S E R V I C E N O T E

HP 3235A/E Switch Test Unit

Link, HP P/N 03235-21203

Procedure to Replace Weak Links on the Mass Quick Interconnect Mechanism

Figure 2: Location of Link Screws

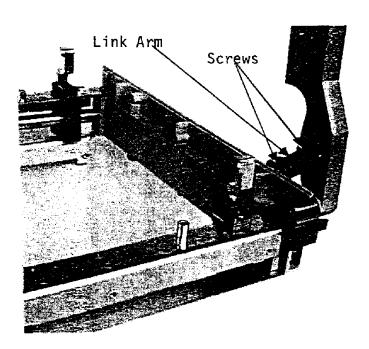
- Remove the Quick Interconnect Assembly, if present. Follow the procedure outlined in the HP 3235A Switch/Test Unit Service Manual (HP P/N 03235-90010),
 Chapter 4 (Mainframe Parts and Disassembly), Section 4-19 (Front Frame or
 Quick Interconnect Assembly Removal).
- 2. Lower the Quick Interface Handles far enough to expose the two (2) 4x8mm screws (per link) which attach each link to the handle and mainframe. See Figure 2.
- 3. Remove the screws and washers, and replace each link.
- 4. Re-assemble.
